TOWN OF PLAINFIELD PLAN COMMISSION REPORT

Hearing Date:	June 15, 2020
Case No.:	PP-20-062
Petitioner:	Matt Oman for Real America LLC
Requested Action:	Primary Plat approval for the re-subdivision of Lots 2 and 3 of Perry Road Business Park at Westcor into Haven Homes Apartments Lots 1 and 2.
Parcel Size:	7.87 acres
Location	East of the intersection of Perry Road and Stout Heritage Parkway, immediately east of 2601 Stout Heritage Parkway
Applicable Regulations:	Plainfield Zoning Ordinance Plainfield Subdivision Control Ordinance Plainfield Comprehensive Plan

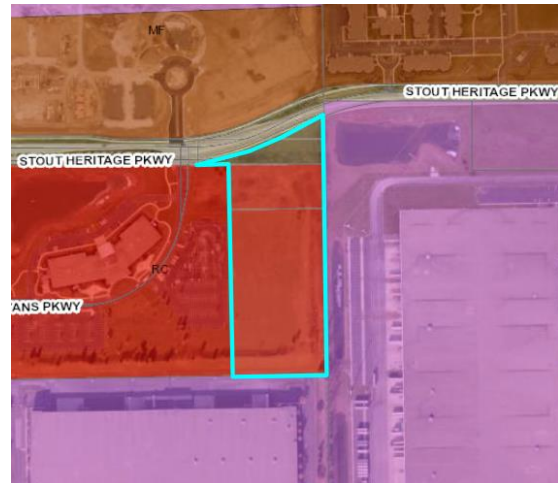
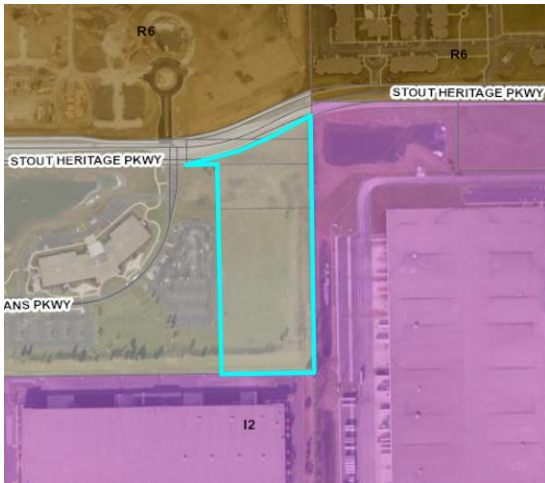
Access for to the project is provided via a single drive from Stout Heritage Parkway. Lot 1 does not include an access easement to serve Lot 2. The plat includes a 15' Drainage and Utility Easement along the east side of both lots and a 20' Drainage, Utility, and Access Easement along the south end of Lot 2.

Public Utilities:	The applicant has not yet been able to make adequate provisions for storm water detention.
Floodplain:	The property is not located within a Special Flood Hazard Area.
Transportation:	The proposed plat dedicates right-of-way for Stout Heritage Parkway in accordance with an existing Development Agreement with the Town Council. Due to the narrow lot ratio, only one direct access to the public right-of-way of Stout Heritage is recommended.

If a second access is determined to be necessary with the planned Future Phase II, the existing Access Easement along the southern edge may be a viable alternative, though it would require coordination with the adjacent lots, particularly the industrial lot to the south where the existing truck court is believed to be constructed it the limits of the existing easement.

1. A cross-parcel access easement is needed to serve Lot 2 which does not have frontage on a public or private street. A waiver to the street standards listed in the Subdivision Control Ordinance would be needed in order to approve the plat as submitted. The applicant did not

file a waiver request. The public notice also did not include any waivers. Staff has advised the applicant to amend the request to either create a one (1) lot subdivision or to reconfigure Lot 2 so that it will have frontage on Stout Heritage.

1. Compliance with the Town Standards, including but not limited to: Plainfield Ordinance 01-2019 regarding Floodplain Management; Plainfield Ordinance Nos. 12-2015 and 06-2017 regarding Sewage Works; Plainfield Ordinance No. 17-97 regarding Drainage; Plainfield Ordinance No. 19-97 regarding Municipal Waterworks; and Plainfield Ordinance No. 18-97 regarding Access Permits.
2. Compliance with the standards and specifications of the Plainfield Subdivision Control Ordinance.
3. Substantial compliance with the primary plat file submitted May 12, 2020.
4. Prior to approval of a Secondary Plat the applicant shall demonstrate that storm water detention requirements have been satisfied.
5. The Primary Plat will include a cross-parcel access easement to ensure future access to public rights-of-way is available for all lots within the subdivision.
